Rezoning Application: PD 24-0932

Development Services Department

Introduction Summary:

The applicant seeks to develop an approximately 2.34-acre property located on the north side of Riverview Drive and south of Brigman Avenue. The request is for a rezoning from Agricultural, Single-Family (AS-1) to Planned Development (PD) to allow for the development of a 50,965-square-foot mini-warehouse and open storage.

2.4 Proposed Site Plan (partial provided below for size and orientation purposes. See Section 8.0 for full site plan)

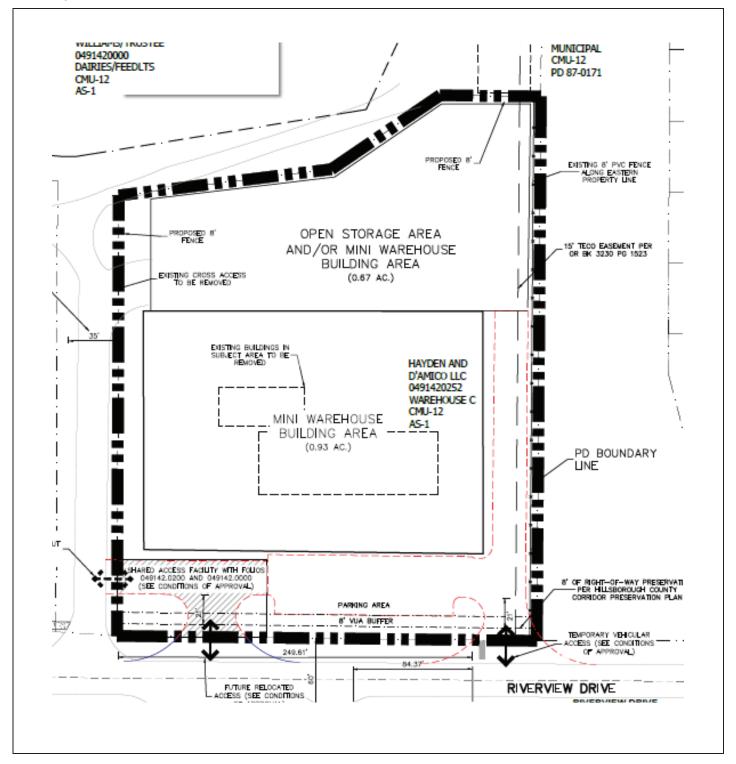
The site plan does not the requirements of LDC Section 6.06.06 Buffering and Screening. The applicant is required to provide a 30-foot-wide buffer with Type "C" screening along the eastern and northern boundary of the adjacent to the residential and agricultural zoning because Open Storage is proposed in the rear of the subject site and is considered a Group 6 use. However, the applicant proposes a variation to allow an increase in fence height along the side and rear perimeters to allow an 8-foot fence which will more effectively screen the outdoor storage from the adjacent properties and public right-of-way than a 6-foot fence.

Sec. 6.06.06 "Buffer Screening matrix" requires a 30-foot landscape buffer along the north and east boundary. Specifically, Section 6.06.06.C.5.a requires in part, a row of evergreen trees and Section 6.06.C.5.c requires in part, low growing evergreen plants. The applicant proposes to reduce the required width of the landscaped buffer from 30 feet to 0 feet due to the extensive buffers on adjacent properties to the north and east.

Sec. 6.06.06 "Buffer Screening matrix" requires a Type "C" screening along the north and east boundary. Specifically, the applicant requests a variation of LDC Section 6.06.06.C.5.b, to not provide a 6-foot masonry wall. Instead, the applicant proposes an 8-foot fence. The applicant states that the impact of the variation to Sec. 6.06.06 will be mitigated by the increased fence height from 6 feet to 8 feet if the second variation is approved, and as shown on the site plan along the east side and rear perimeters of the PD.

Sec. 6.06.06 "Buffer Screening matrix" requires a 20-foot landscape buffer along the north and east boundary. Specifically, Section 6.06.06.C.4 requires in part, a row of evergreen trees spaced not more than 10-ft. apart and a solid 6-foot-high PVC/wooden fence along with low growing evergreen plants. The applicant proposes to reduce the required width of the landscaped buffer from 20 feet to 0 feet due to the extensive buffers on adjacent properties to the north and east.

- Correct the Mini-warehouse acreage under "Proposed Use" from 0.93 ac. to 2.34 ac. for Mini-warehouse.
- Clearly delineate with "dotted lines" area where Open Storage shall be permitted.
- Shift the internal driveway westward off the 15' TECO easement area.
- Remove 8' fence shown on site plan along the western property boundary.

- 1. The project shall be developed in general conformance with the August 28, 2024, site plan and be limited to the following uses.
 - Open Storage is allowed as specified on the site plan in the 0.67-acre area located in the northern portion
 of the subject property.

- 4. The subject property shall be subject to buffering and screening requirements of Section 6.06.06 of the Hillsborough County Land Development Code with the following exceptions.
 - a. A zero-foot buffer with an 8-foot opaque fence shall be allowed along the northern and eastern property boundary for both Open Storage and Mini-warehouse uses.
- 5. It is the County's intent to plan for a shared access connection to Riverview Dr., serving the subject PD as well as folios 49142.0000 and 49142.0200, to be completed by others in the future, and which shall take the place of the shared access currently within 49142.0000. In order to facilitate interim access for the subject PD, project access shall be phased as follows:
 - a. Initial project access to Riverview Dr Rd. shall occur in the location shown as "Temporary Vehicular Access" on the PD site plan.

2.4 Proposed Site Plan (partial provided below for size and orientation purposes. See Section 8.0 for full site plan)

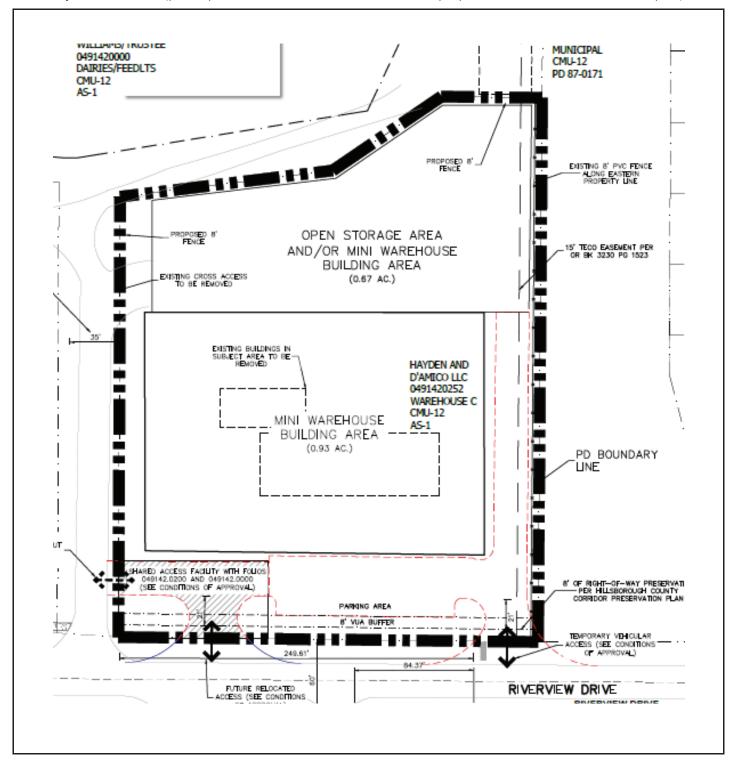
The site plan does not the requirements of LDC Section 6.06.06 Buffering and Screening. The applicant is required to provide a 30-foot-wide buffer with Type "C" screening along the eastern and northern boundary of the adjacent to the residential and agricultural zoning because Open Storage is proposed in the rear of the subject site and is considered a Group 6 use. However, the applicant proposes a variation to allow an increase in fence height along the side and rear perimeters to allow an 8-foot fence which will more effectively screen the outdoor storage from the adjacent properties and public right-of-way than a 6-foot fence.

Sec. 6.06.06 "Buffer Screening matrix" requires a 30-foot landscape buffer along the north and east boundary. Specifically, Section 6.06.06.C.5.a requires in part, a row of evergreen trees and Section 6.06.C.5.c requires in part, low growing evergreen plants. The applicant proposes to reduce the required width of the landscaped buffer from 30 feet to 0 feet due to the extensive buffers on adjacent properties to the north and east.

Sec. 6.06.06 "Buffer Screening matrix" requires a Type "C" screening along the north and east boundary. Specifically, the applicant requests a variation of LDC Section 6.06.06.C.5.b, to not provide a 6-foot masonry wall. Instead, the applicant proposes an 8-foot fence. The applicant states that the impact of the variation to Sec. 6.06.06 will be mitigated by the increased fence height from 6 feet to 8 feet if the second variation is approved, and as shown on the site plan along the east side and rear perimeters of the PD.

Sec. 6.06.06 "Buffer Screening matrix" requires a 20-foot landscape buffer along the north and east boundary. Specifically, Section 6.06.06.C.4 requires in part, a row of evergreen trees spaced not more than 10-ft. apart and a solid 6-foot-high PVC/wooden fence along with low growing evergreen plants. The applicant proposes to reduce the required width of the landscaped buffer from 20 feet to 0 feet due to the extensive buffers on adjacent properties to the north and east.

- Correct the Mini-warehouse acreage under "Proposed Use" from 0.93 ac. to 2.34 ac. for Mini-warehouse.
- Clearly delineate with "dotted lines" area where Open Storage shall be permitted.
- Shift the internal driveway westward off the 15' TECO easement area.
- Remove 8' fence shown on site plan along the western property boundary.

- 1. The project shall be developed in general conformance with the August 28, 2024, site plan and be limited to the following uses.
 - Open Storage is allowed as specified on the site plan in the 0.67-acre area located in the northern portion
 of the subject property.

- 4. The subject property shall be subject to buffering and screening requirements of Section 6.06.06 of the Hillsborough County Land Development Code with the following exceptions.
 - a. A zero-foot buffer with an 8-foot opaque fence shall be allowed along the northern and eastern property boundary for both Open Storage and Mini-warehouse uses.
- 5. It is the County's intent to plan for a shared access connection to Riverview Dr., serving the subject PD as well as folios 49142.0000 and 49142.0200, to be completed by others in the future, and which shall take the place of the shared access currently within 49142.0000. In order to facilitate interim access for the subject PD, project access shall be phased as follows:
 - a. Initial project access to Riverview Dr Rd. shall occur in the location shown as "Temporary Vehicular Access" on the PD site plan.
